SUBJECT: AMENDMENT NOS. 142 AND 146 TO FACILITY OPERATING LICENSE NOS. DPR-24
AND DPR-27 (TAC NOS. M86783 AND M86784)

POINT BEACH NUCLEAR PLANT, UNIT NO. 1

POINT BEACH NUCLEAR PLANT, UNIT NO. 2

SAFETY EVALUATION BY THE OFFICE OF NUCLEAR REACTOR REGULATION

Figure 15.2.1-1
REACTOR CORE SAFETY LIMITS
POINT BEACH UNIT 1

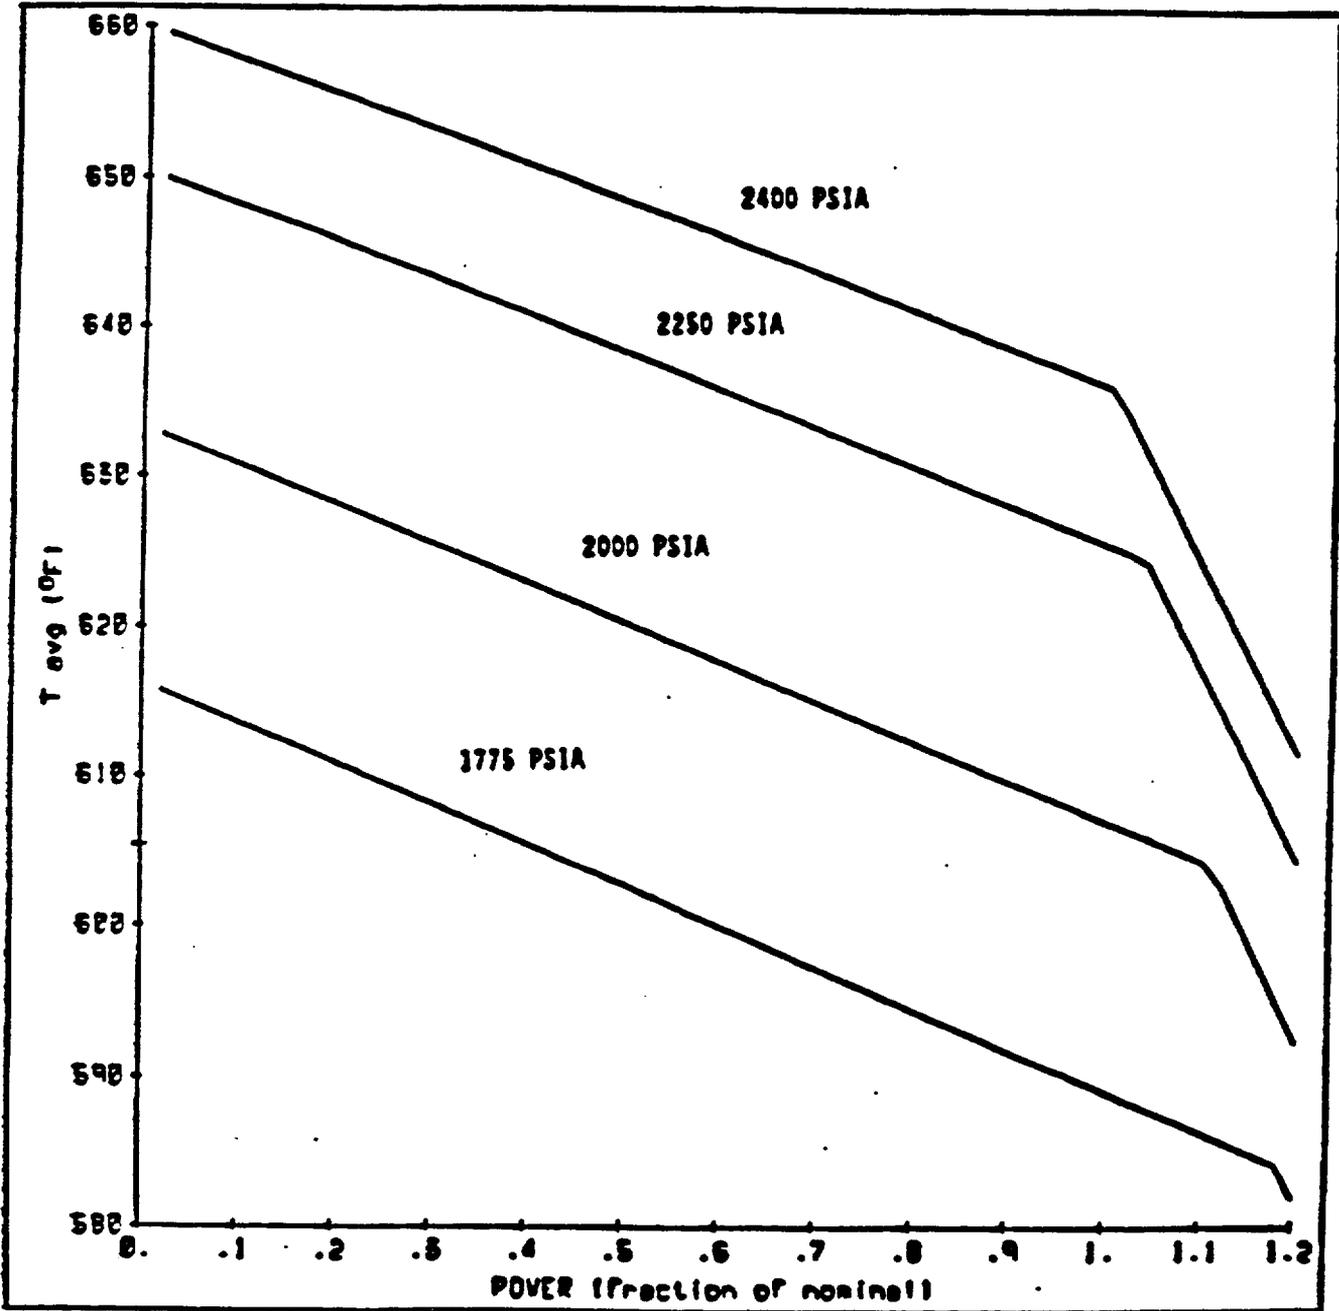
- (1) A new figure is being added to TS 15.2.1, "Safety Limit, Reactor Core," which is applicable to Unit 2. The title of the existing figure is being modified to indicate it is applicable to only PBNP, Unit 1.
- (2) TS 15.2.3.1.B(4) and (5) is being modified as follows:
 $T' \leq 573.9$ °F (Unit 1)
 $T' \leq 570.0$ °F (Unit 2)
- (3) TS Section 15.3.1.G, "Operational Limitations," is being modified to provide Reactor Coolant System flow limits specific to each unit as follows:

- (1) A new figure was added to TS 15.2.1, "Safety Limit, Reactor Core," which is applicable to Unit 2. The title of the existing figure was modified to indicate it is applicable to only PBNP, Unit 1. TS 15.2.1 was modified to read:

- "1. The combination of thermal power level, coolant pressure, and coolant temperature shall not exceed the limits shown in Figure 15.2.1-1 for Unit 1 and Figure 15.2.1-2 for Unit 2."

Figure 15.2.1-2
REACTOR CORE SAFETY LIMITS
POINT BEACH UNIT 2

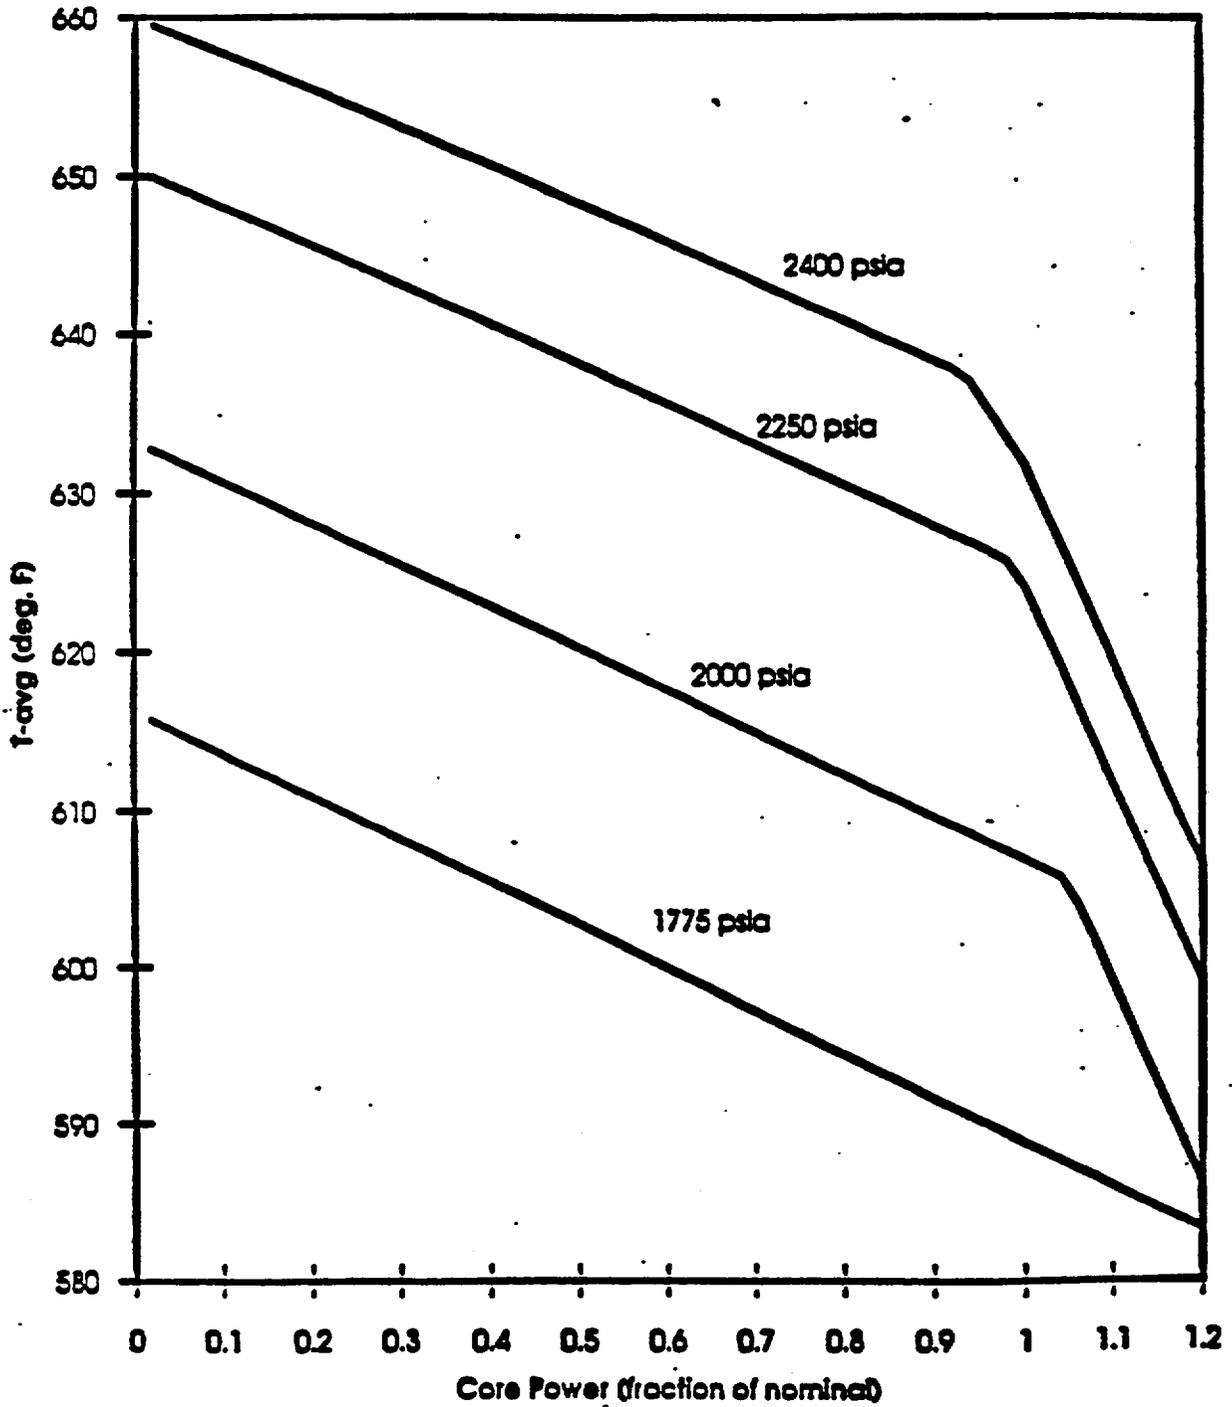
The proposed change to reduce the RCS measured total flow rate by 2,600 gpm (1.4 %) for Unit 2 requires a change to the Reactor Core Safety Limits graph which in turn causes the Overtemperature and Overpower ΔT setpoints to be changed. The licensee proposed TS changes which will revise the reactor core safety limits figure, overtemperature ΔT setpoint, overpower ΔT setpoint, and the minimum RCS flow rate for Unit 2.

"The curves of Figure 15.2.1-1 and 15.2.1-2 are applicable for 14 x 14 OFA. The curves also apply to the reinsertion of previously-depleted 14 x 14 standard fuel assemblies into an OFA core."
